With reference to his application dated 31st October 1918 with a plan for the proposed additions and alterations on plot No. 97 K-4 Layari quarter Mr. Ghulam Hussain Bhaladina is informed Kitchens of dimensions in proportion to the size of the living rooms to be provided.

PROPOSED ALTERATIONS & ADDITIONS

ON PLOT NO 97 SHEET K-4.

LYAREE QUARTERS

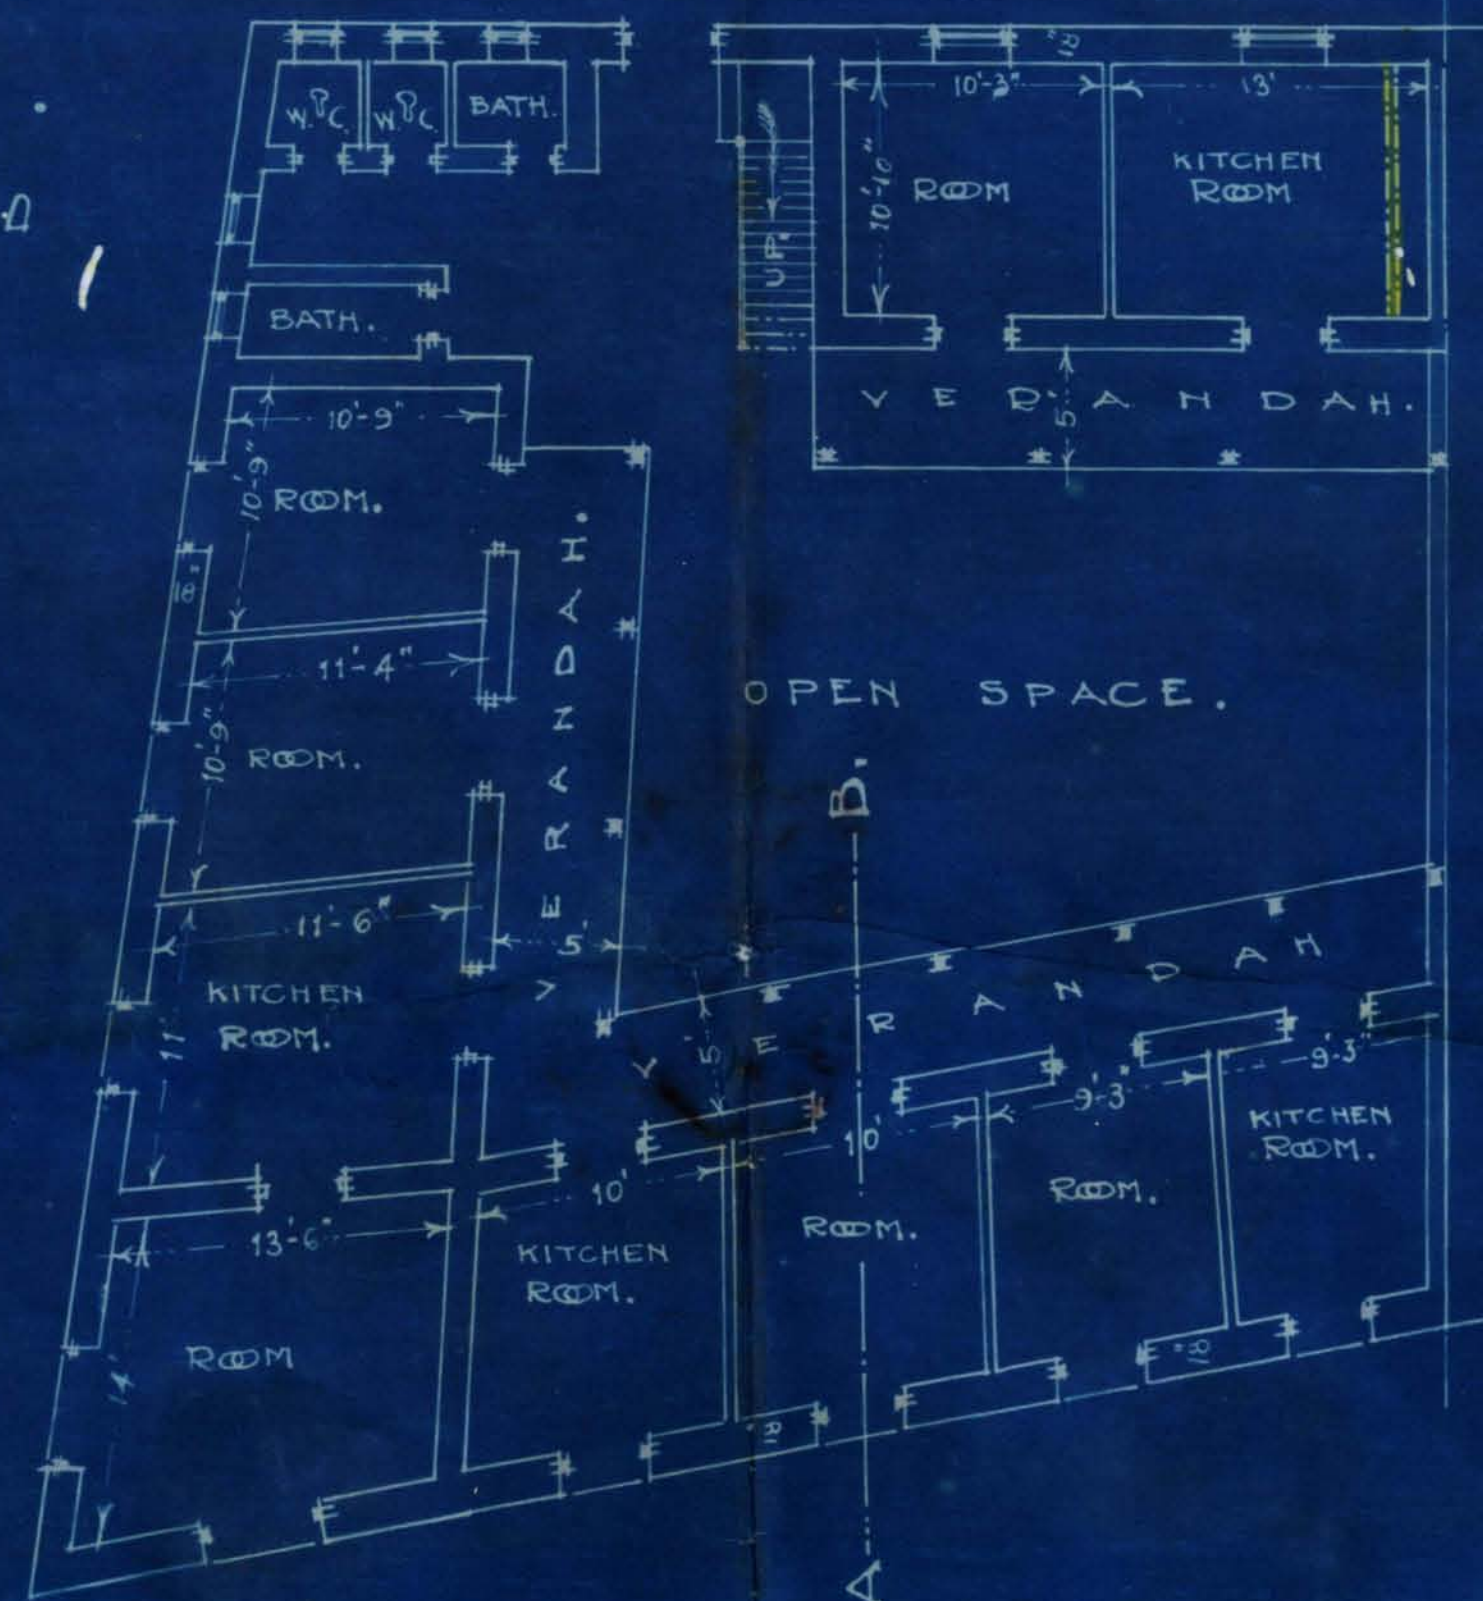
The front wall is ^{an} old one without through stones. ~~Razmik~~ Permission to build first floor on it cannot be granted.

The end wall and one cross wall must be made Pukka.

*So called kitchens are always
used in living rooms. It is not possible
to believe that for proper cleaning
such a large room will be utilized
for kitchens. Separate kitchen therefore
should be provided. They will
cook in the living rooms.*

Building Surveyor's Report In with respect to this I beg
to report that the H.O.'s remarks are
quite reasonable. (2) The state of the
present work is not sufficient to carry
the superincumbent wt of 1st floor that
will be brought to bear upon it (3) The party
wall bet plots 97 + 98 must be pulled
 Date 22/10/ 1919 J. J. Jago
 Building Surveyor.

Does the plot come under Alignment No
 Area of plot —
 Area under Alignment —
 Remarks See, they to upon that a proper
kitchen rooms take shown on the
proper place in this case kitchen is
larger than room. otherwise there
is no objection M. M. M.
 Date 22-10 1919 M. M. M.
 Land Surveyor.

In upon applicant his plan is
disapproved. Kitchen of dimensions
in proportion to the size of the big
rooms take provided

The front wall has no
through stones & cannot be
is. The end wall some across wall to
is not properly bonded in the front wall
